National Committee on Uniform Traffic Control Devices

NCUTCD Proposal for Changes to the Manual on Uniform Traffic Control Devices

ITEM NUMBER: 19A-RR-02

TOPIC: Clearance from Flashing-Light Signal with or without Automatic Gate to Track

56 05 **Location and clearance dimensions for flashing-light signals and gates shall be as shown**
57 **in Figure 8C-1.**

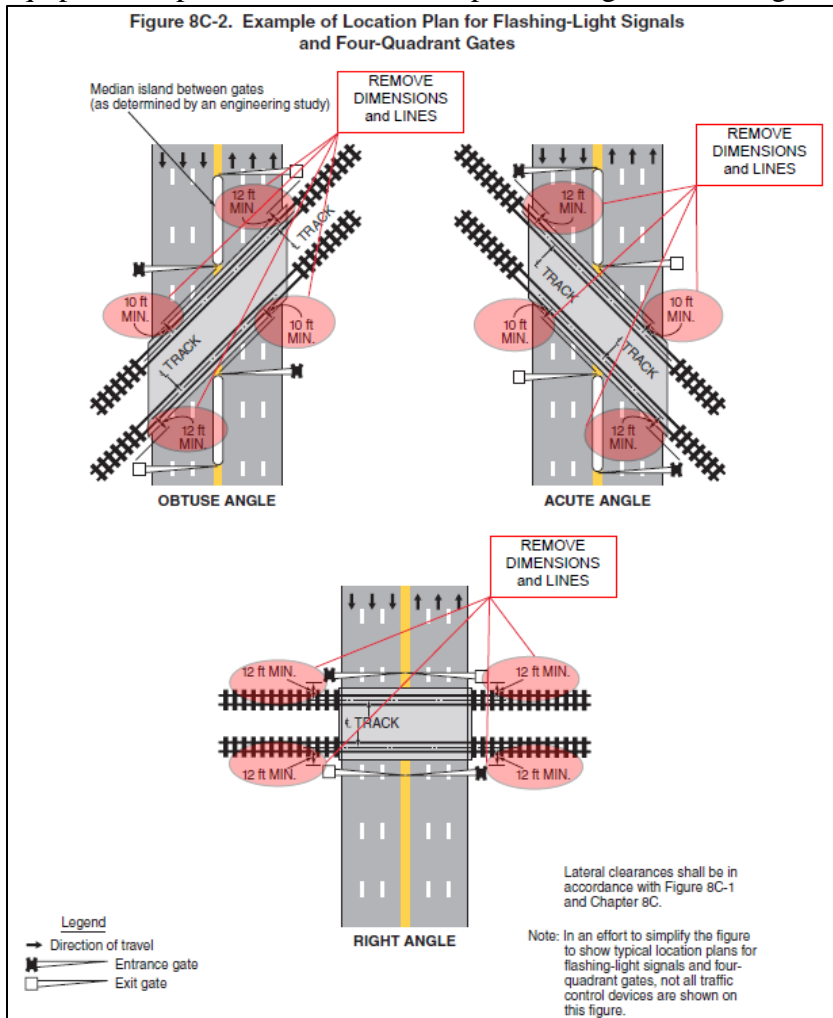
67 08a **Minimum clearance dimensions for flashing lights and automatic gates relative to the**
68 **proximity to the closest track shall conform to standards provided by the railroad company**
69 **and/or transit agency.**
